LFPCNUSA2023-001 Product Change Notification for Littelfuse

MOSFET DISCRETE, IGBT DISCRETE over 650V in TO-247 package adding new manufacturing location

1. POD – Package Outline Dimension

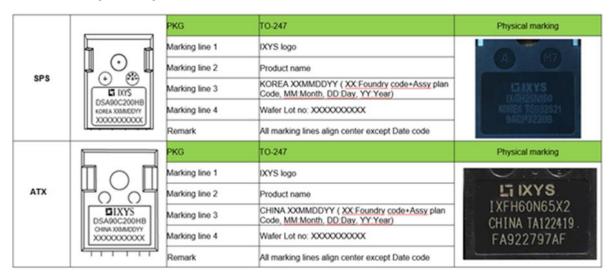
ATX POD has different dimension and shape on body notch area compared to Littelfuse Original POD

Conclusion: There is variance between the POD of Littelfuse and ATXWH on outline E2 and L. The variance is not critical which has no significant impact on the application in customer side.

Datasheets will be updated.

2. Package Marking

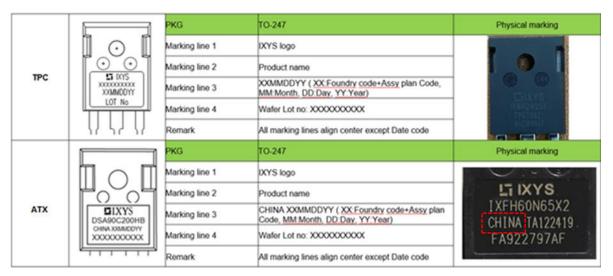
Conclusion: No change on the marking rule between SPS and ATXWH

Conclusion: Slight change on the marking rule between TPC and ATXWH, ATX has added original country in the marking, which is aligned with the marking rule in SPS.

3. BOM

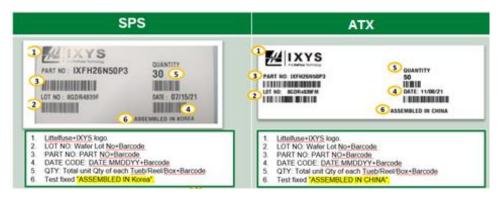
Conclusion: There is variance between the BOM of SP Semi/TPC and ATXWH on Lead-frame, Solder wire, and lead finish.

4. Label

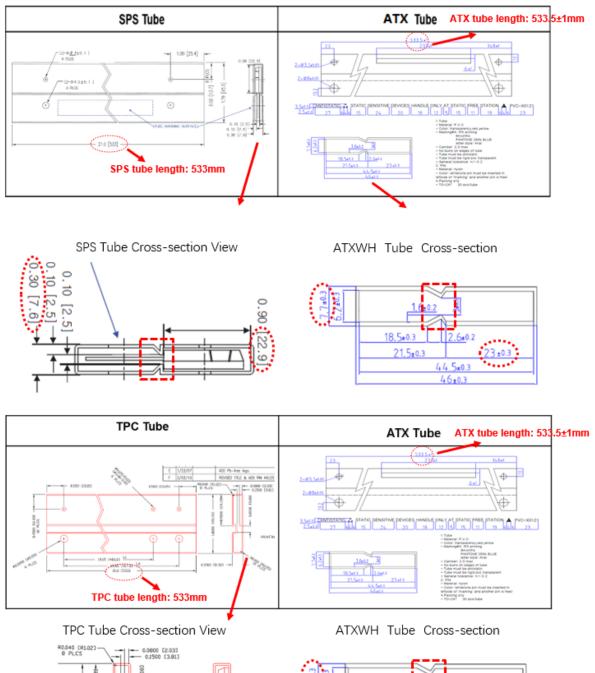
Note: (1). No additional change in Label layout for Logo/Part No/Lot No/Qty/Date Code between SPS and ATX. The only change is for assembly location from Korea to China.

Note: (2). No additional change in Label layout for Logo/Part No/Lot No/Qty/Date Code between TPC and ATX. However, there is a change on the logo location (TPC: Right-up corner VS ATX: Left-up corner) and assembly location from Philippines to China.

Note: (3). For ATX labeling, there will be ATX super lot# printed in a separate label and this label will only be attached to inner box as below.
